## Service Bulletin

Reference # 2012-003

**Subject: BI-ANNUAL REPLACEMENT OF OUTBOARD SLEWING BEARING BOLTS:**

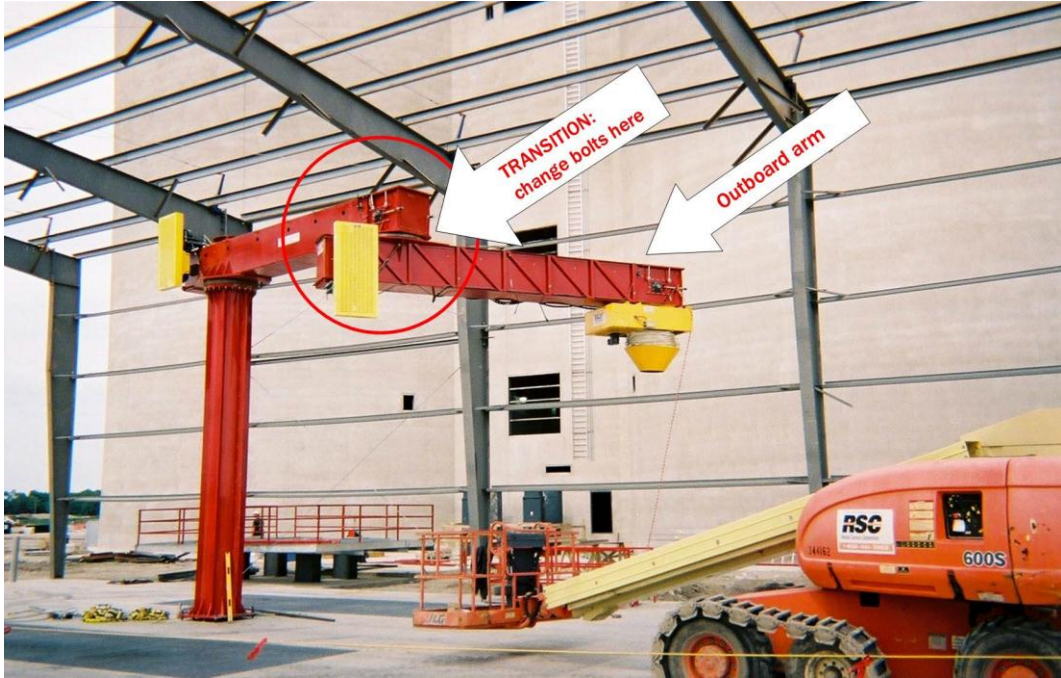
*Normal operating use an articulated loading conveyor can cause the Grade 8 bolts used to attach the outboard conveyor arm to the transition slewing bearing to harden and crack. As a result, for safety reasons, we strongly recommend replacing these bolts every 2 years. **Warning: Bolt failure could cause the loading arm to break free from the slewing bearing and fall resulting in damage or personal injury.***

- 1) Locate the (2) access holes on the transition between the main conveyor and the outboard conveyor. There is (1) access holes on each side of conveyor.
- 2) Rotate the outboard conveyor arm until the bolt head is in view in the access hole.
- 3) Use a  $\frac{3}{4}$ " socket to remove the bolt.
- 4) Immediately replace the bolt with a new  $\frac{1}{2}$ " diameter, 13 x 2  $\frac{3}{4}$ " Grade 8 bolt.
- 5) Torque the bolt to 70 ft. lbs. if the bolt is pre-lubricated or 110 ft. lbs. if the bolt is dry.
- 6) Mark the bolt with a magic marker to indicate that it's been replaced.
- 7) Locate the access hole on the opposite side of the loading arm and move the loading arm until a bolt head is visible through that access hole.  
Repeat steps 3 through 6.
- 8) Rotate the outboard arm to the next set of bolts and repeat steps 3 through 7 until all bolts have been changed out.
